URGENT MEDICAL DEVICE CORRECTION**September 10, 2019****To:** Hospital/Surgeon Name**Affected Product:** ROSA Brain 3.0**Serial No.:** BRxxxxx

ROSA Brain 3.0

Medtech S.A - Zimmer Biomet - is initiating a medical device Field Safety Corrective Action for ROSA Brain 3.0 products. This notice informs you of the issue and the corrective actions Zimmer Biomet is taking.

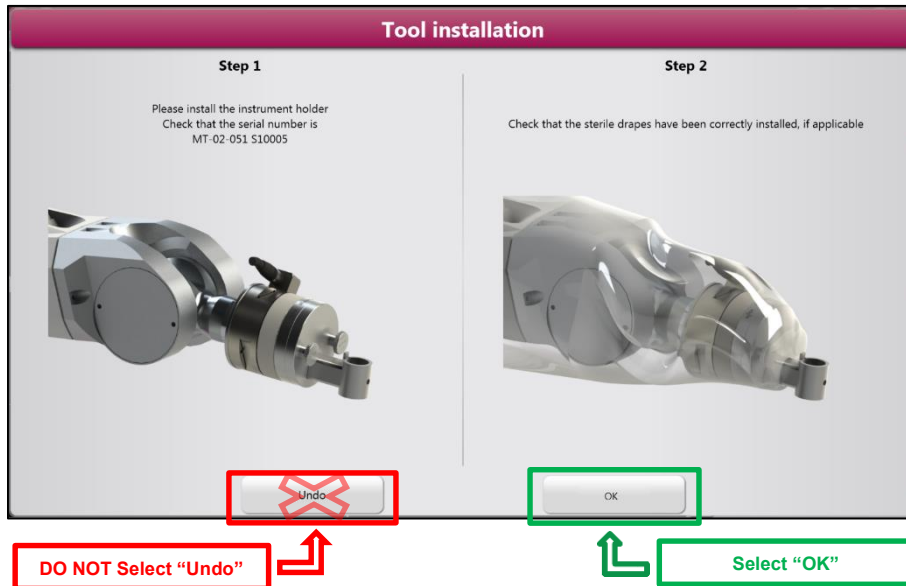
After the registration of the patient within the ROSA Brain 3.0 device, the issue may occur only in the guidance mode (e.g. when the robot arm is on trajectory), when the user selects the optical distance sensor and sends the robot arm on each entry point, and then selects the instrument holder. In such case, the use of the "Undo" button in the Tool installation panel will result in the issue due to a software anomaly.

Actions Required By Users (Workaround):

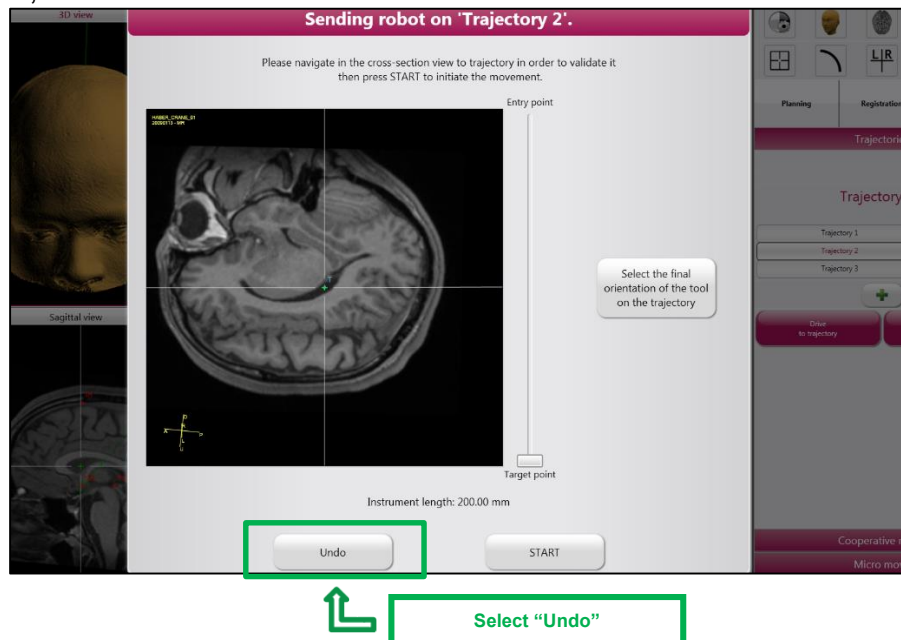
- Once you select the instrument holder, if you would like to Undo your action :
 - DO NOT select "Undo"
 - Select "OK"

- In the next frame, select Undo

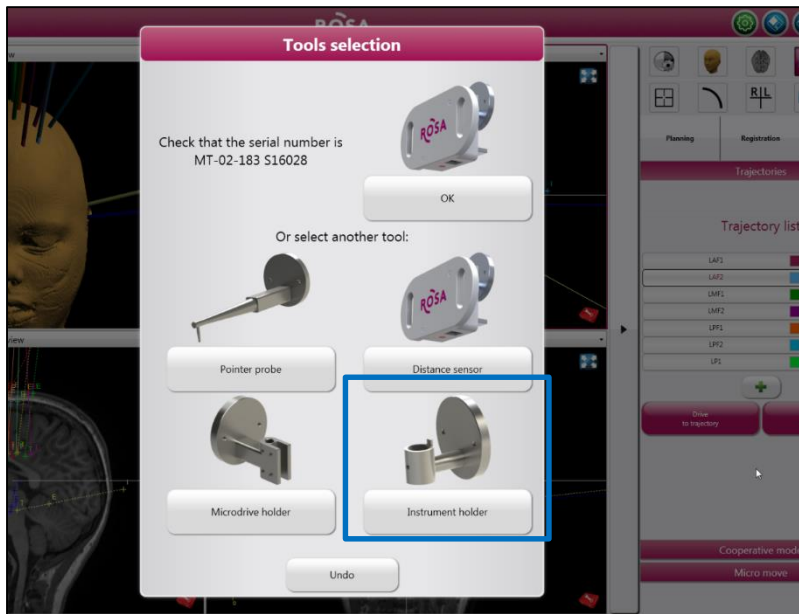
1. Use of the optical distance sensor during guidance mode, e.g. to mark entry points on the patient's head with a skin marker
2. Choosing drive to a trajectory and selection of the instrument holder

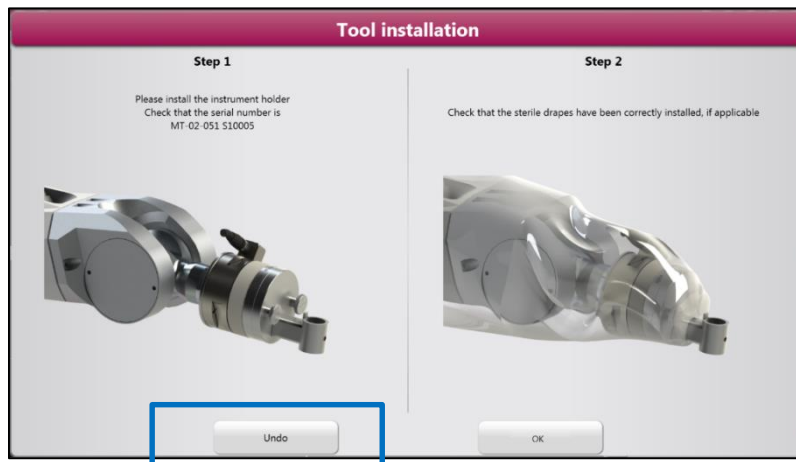
3. Installation of the instrument holder on the robot arm
4. Clicking undo on the tool installation frame

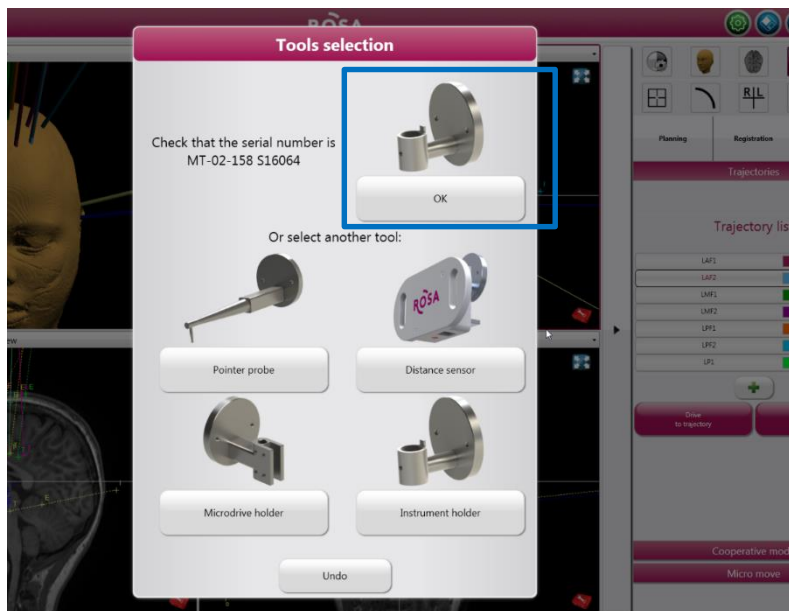
5. Choosing drive to a trajectory, then re-selection of the current instrument holder and drive to the trajectory

If the above listed steps are performed, the instrument holder may be sent on a trajectory that is not within the intended target.
